**REQUEST FOR QUOTATION
RFQ #04 (2018-01)
GENERATOR INSTALLATION
AFRICAN RAINFOREST PAVILION
ADDENDUM # 2**

ADDENDUM

This Addendum has been issued for RFQ 04 (2018-01) and is to be read in conjunction with the drawings and specifications, and to be part of the tender documents.

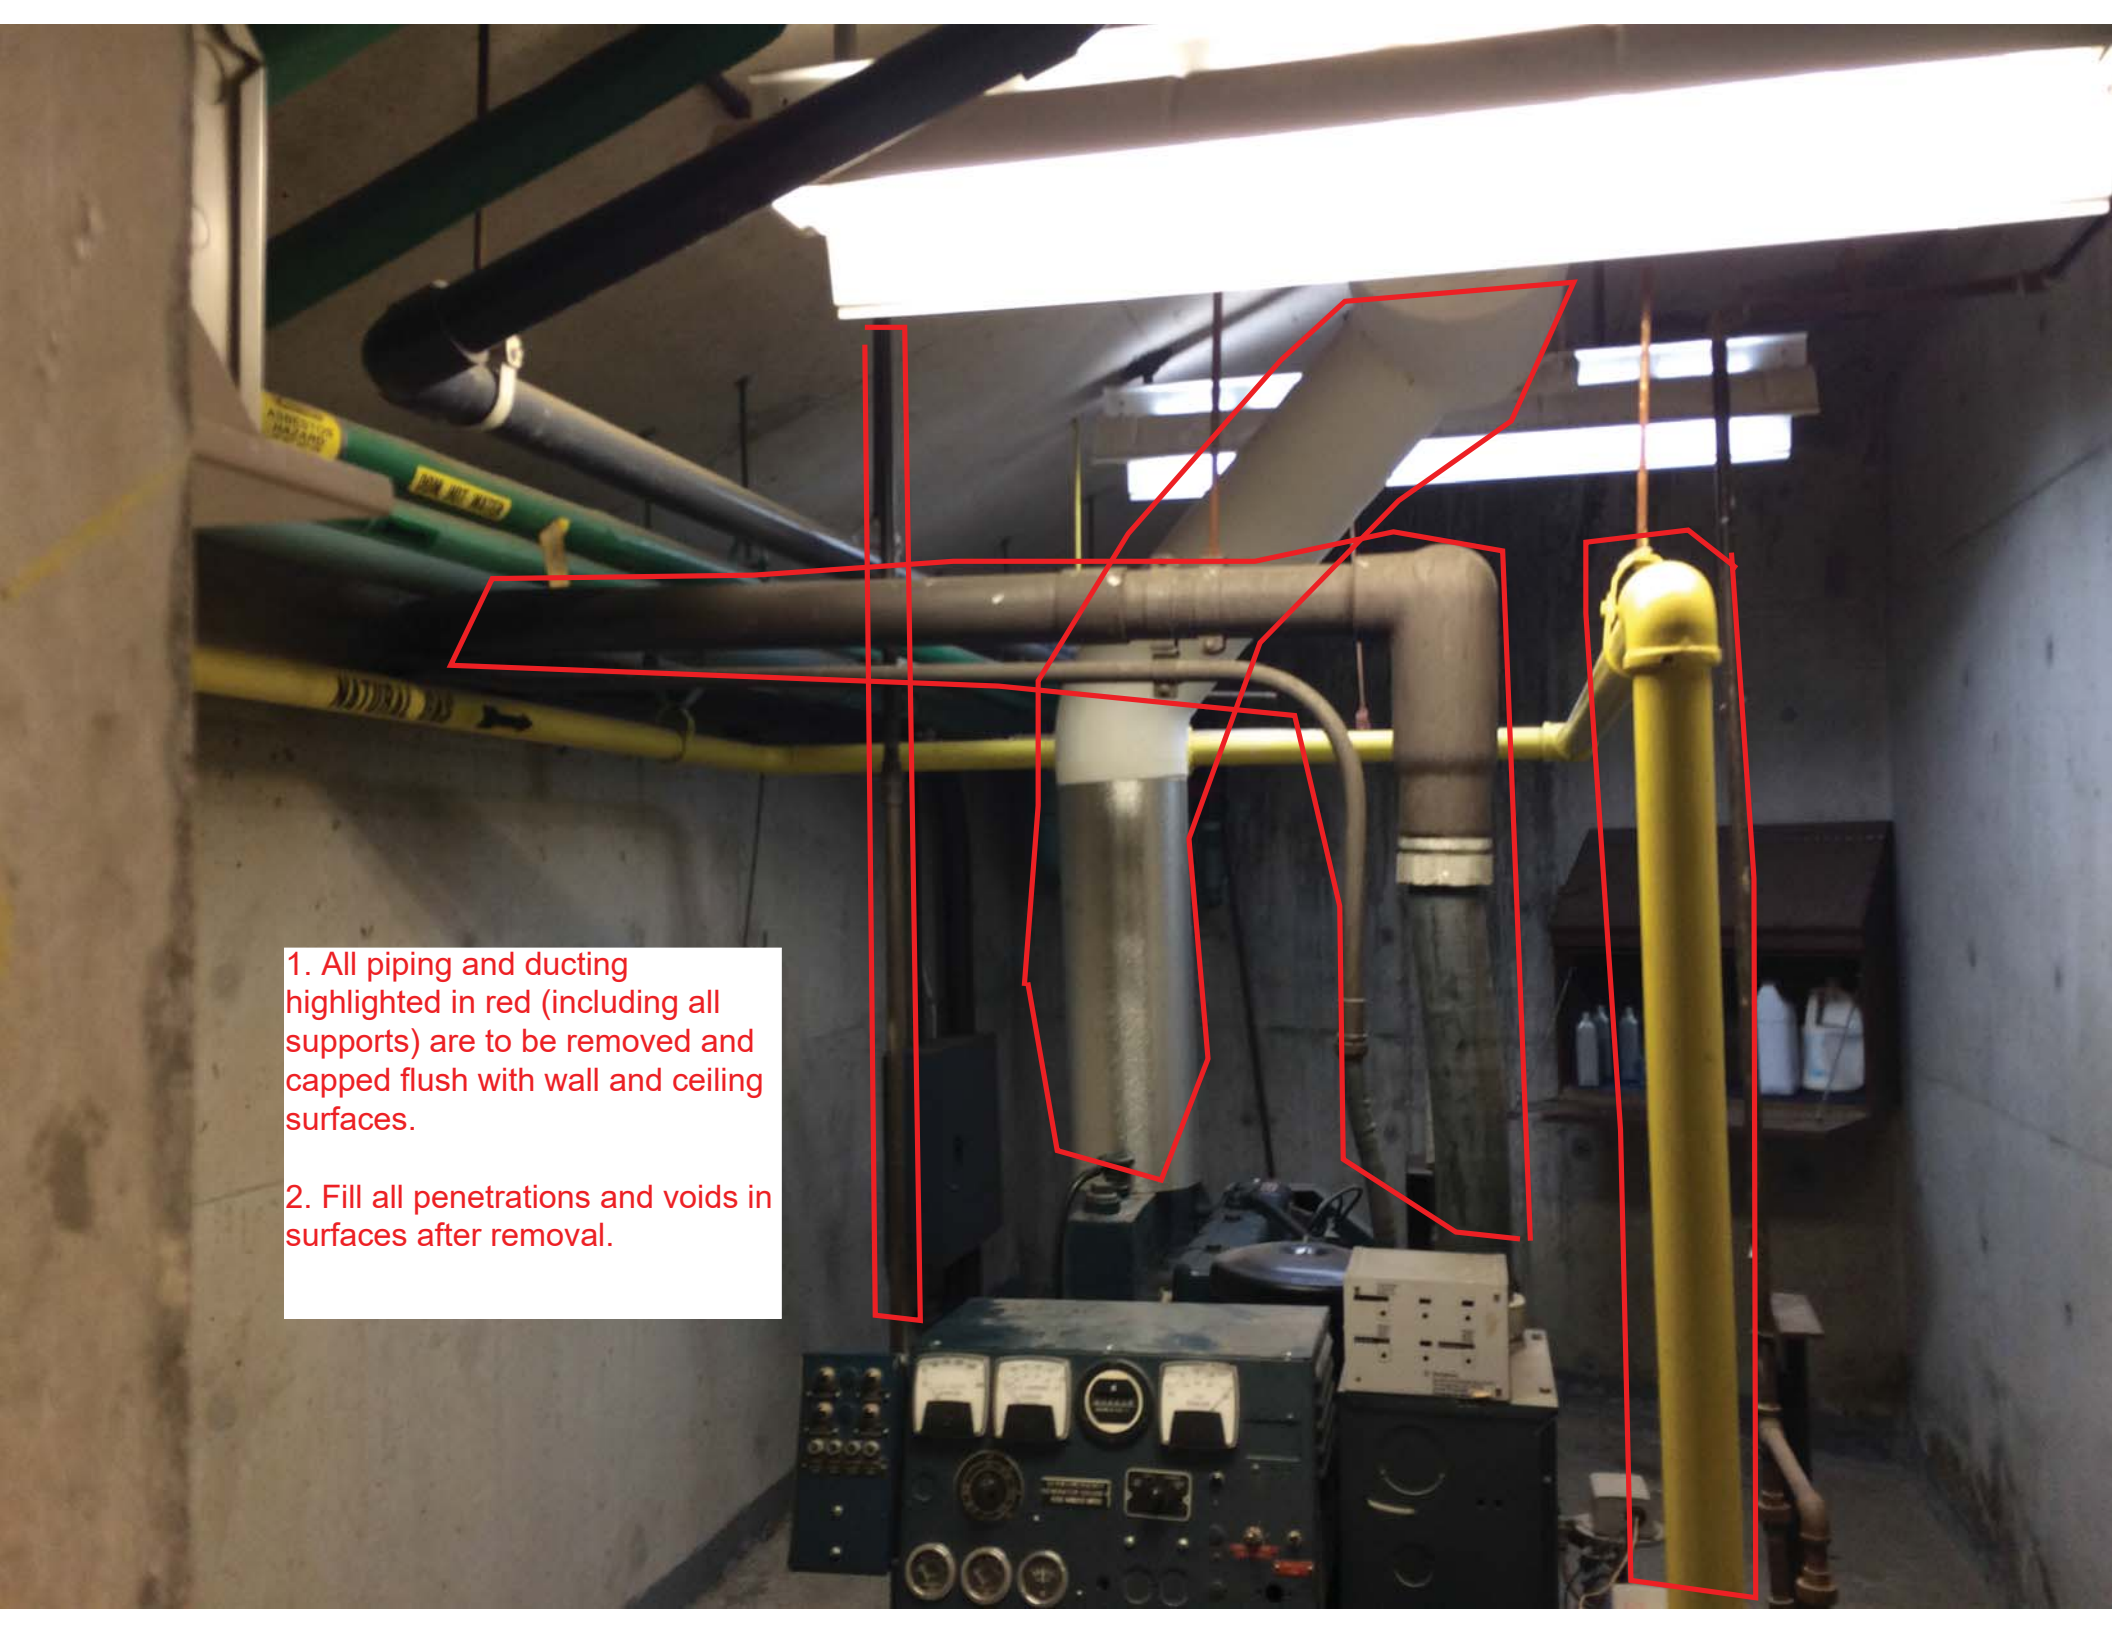
Please provide detailed Mechanical Drawing and Scope for the Generator Removal so we can obtain pricing for required Mechanical Disconnects and removals as required.

These drawings are not available. Please see attached photograph with highlighted items to be removed and capped. Anchor bolts in concrete base to be cut and ground flush with surface.

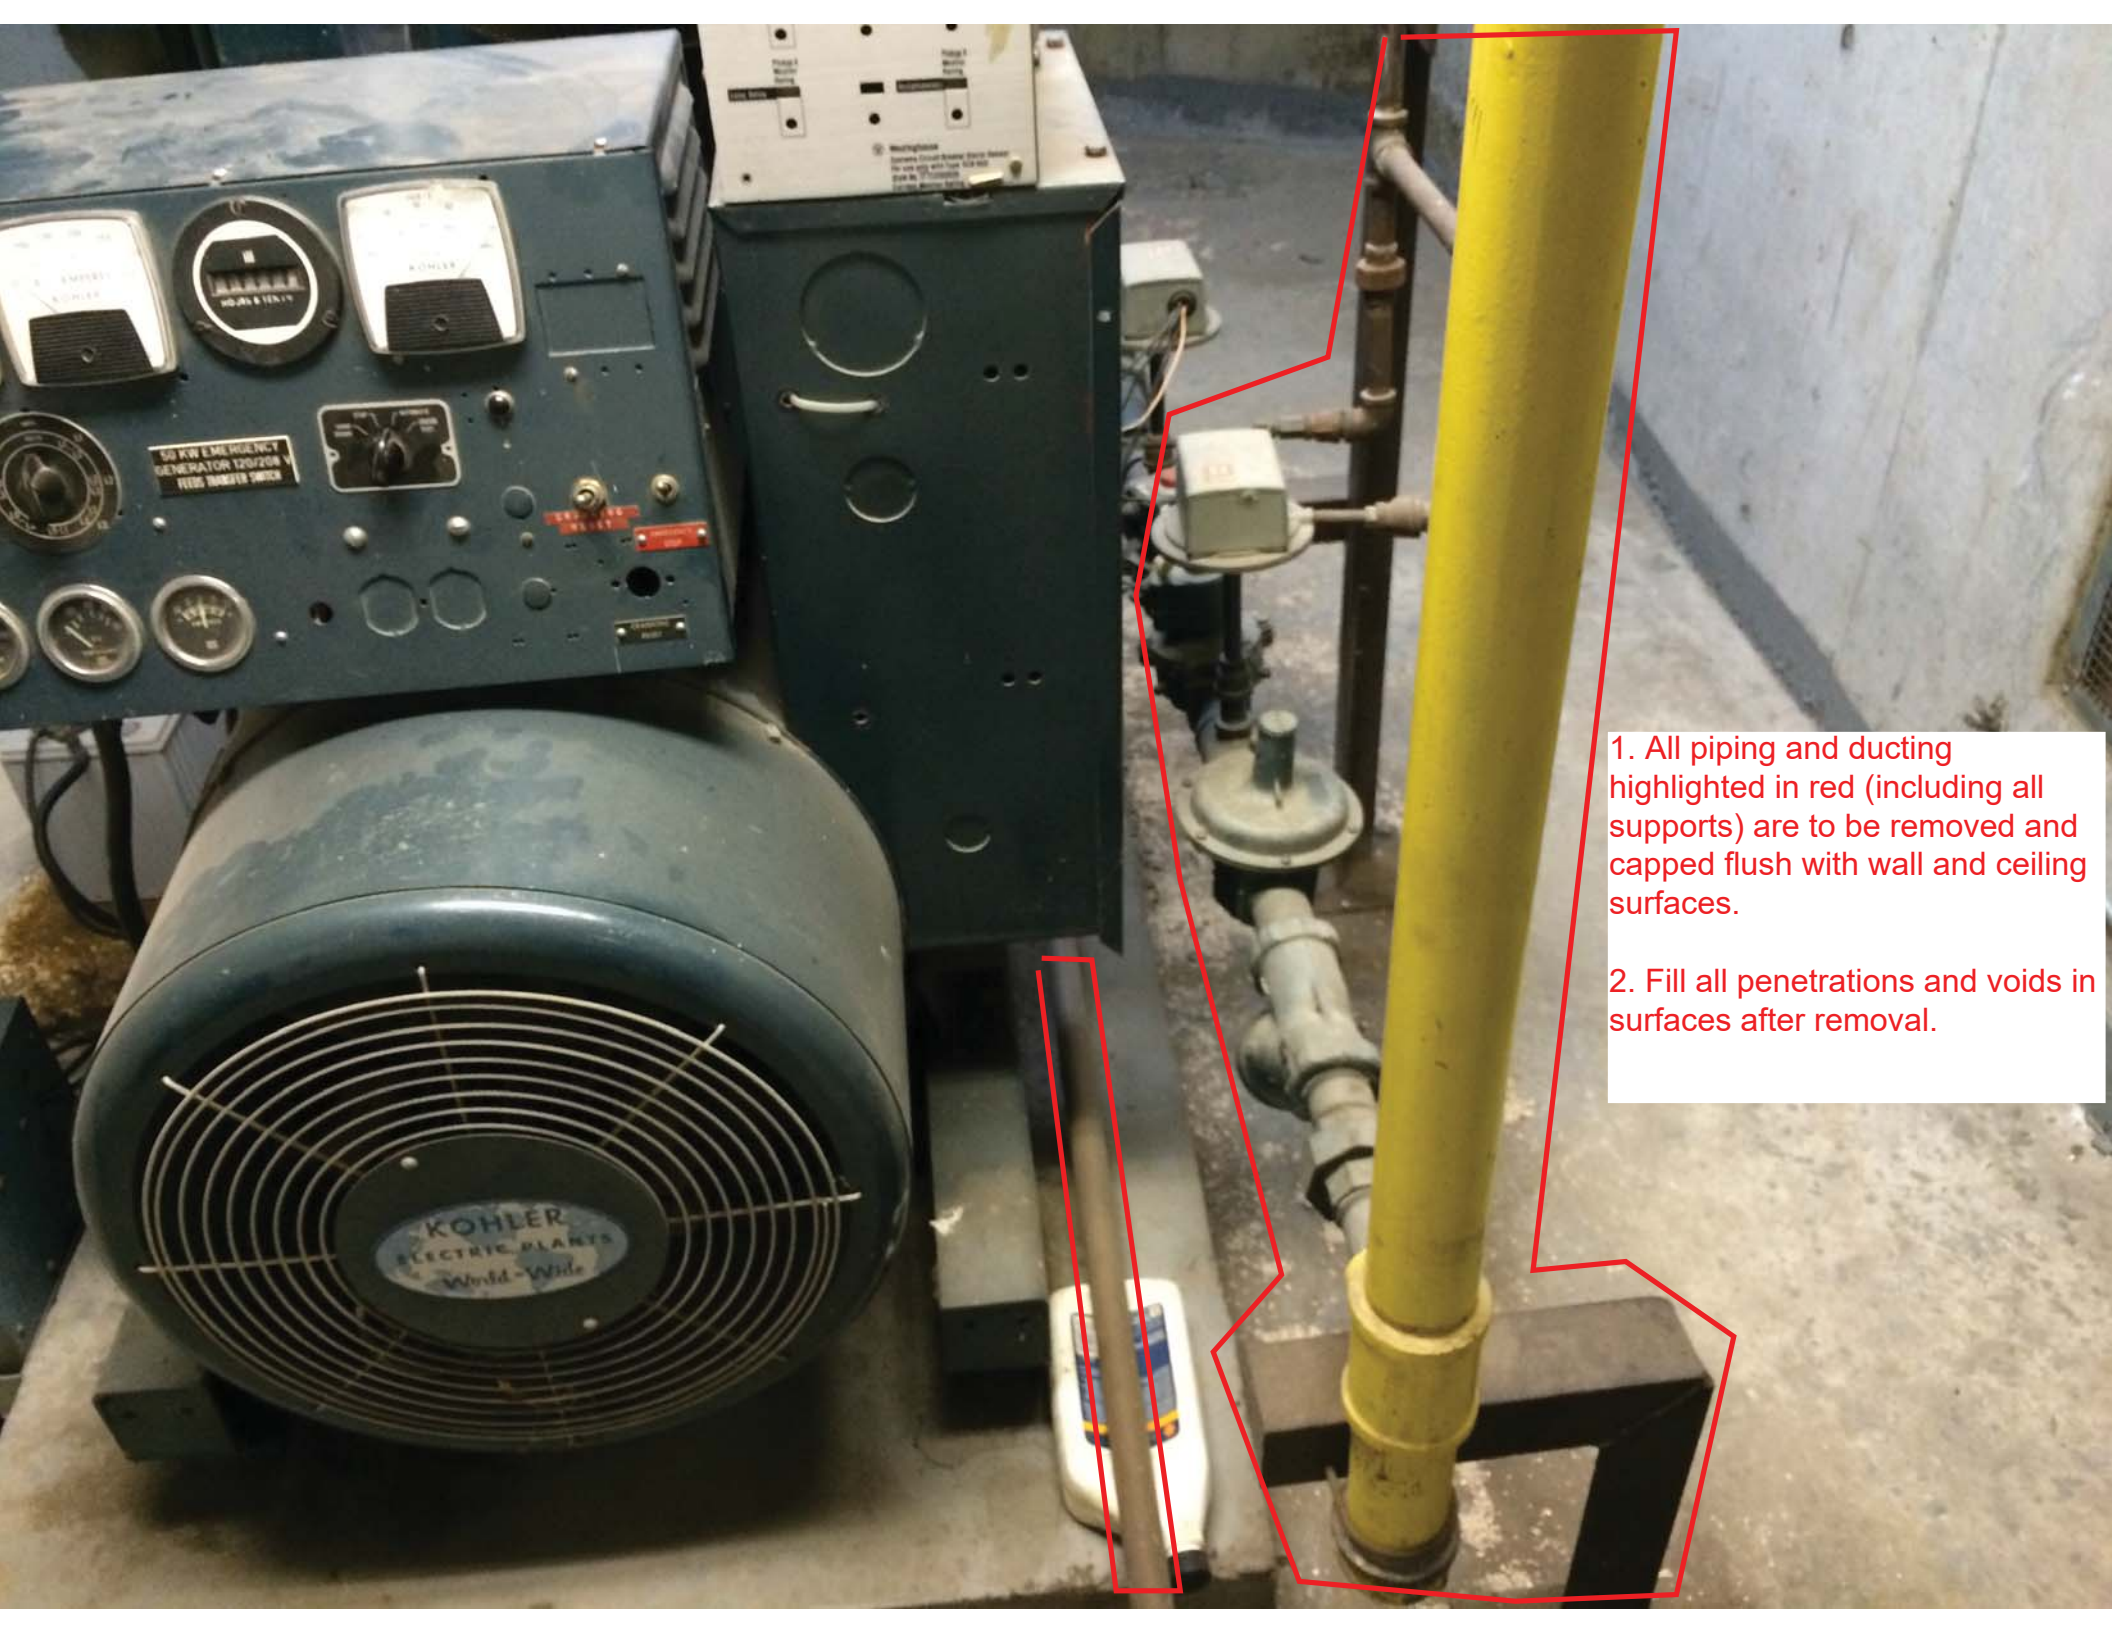
1. All piping and ducting highlighted in red (including all supports) are to be removed and capped flush with wall and ceiling surfaces.

2. Fill all penetrations and voids in surfaces after removal.

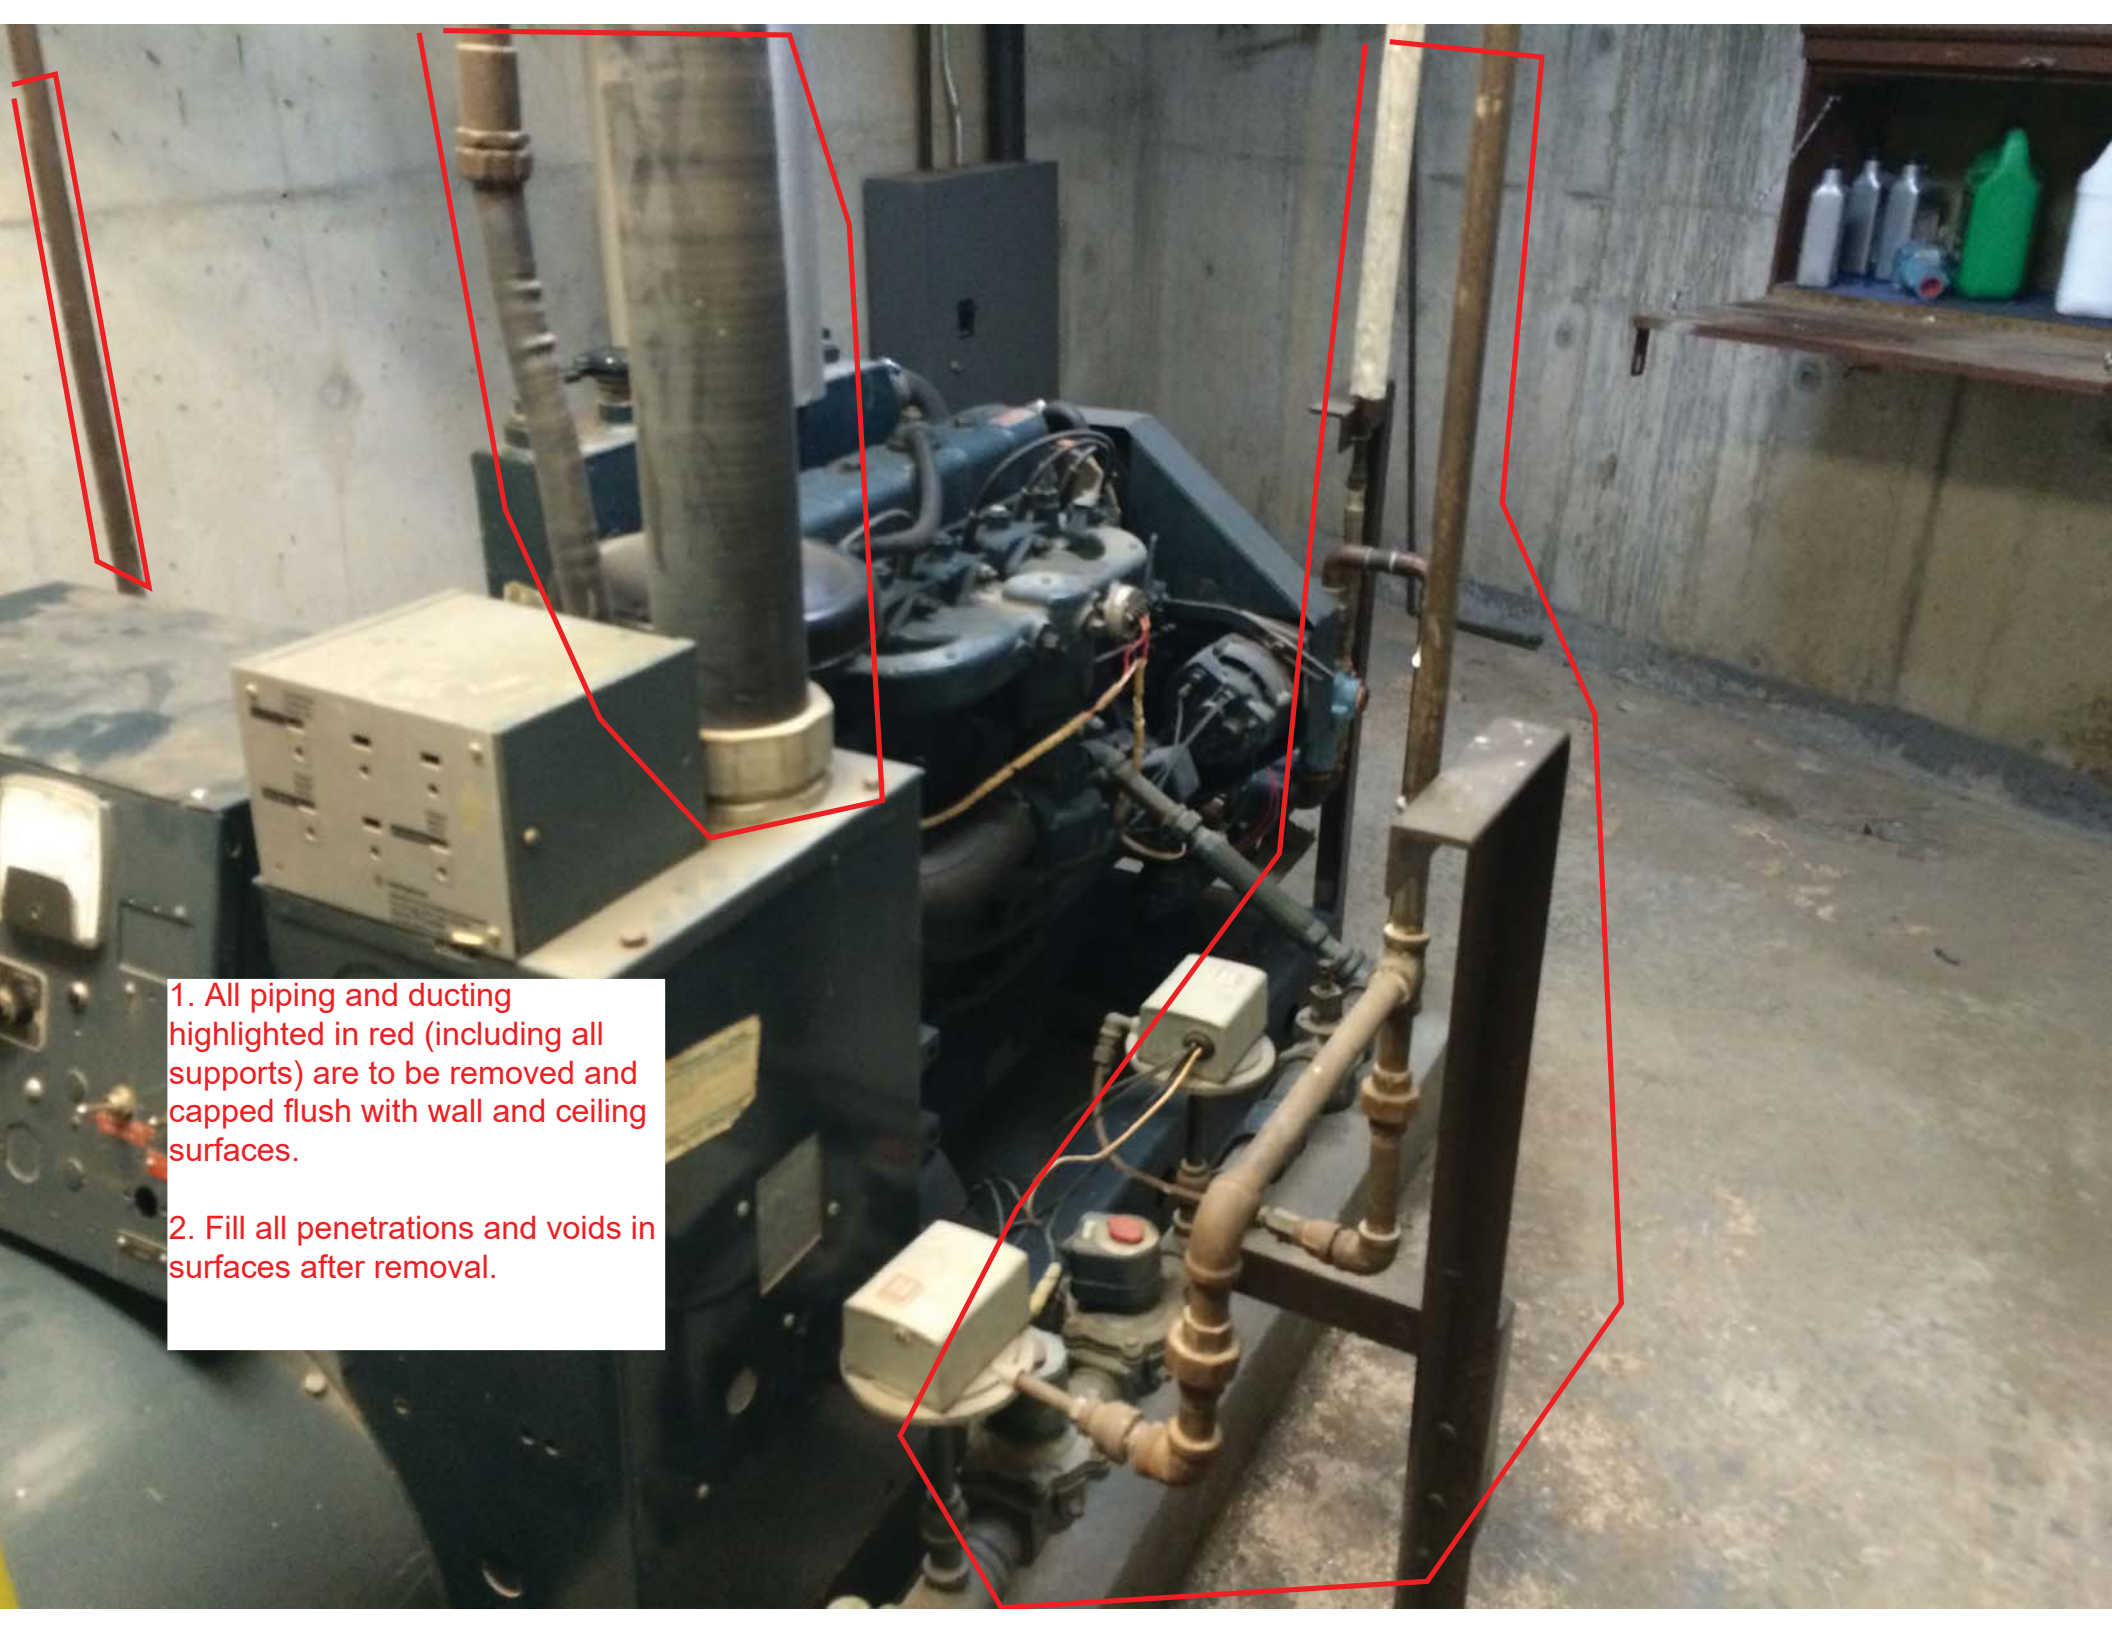
1. All piping and ducting highlighted in red (including all supports) are to be removed and capped flush with wall and ceiling surfaces.

2. Fill all penetrations and voids in surfaces after removal.
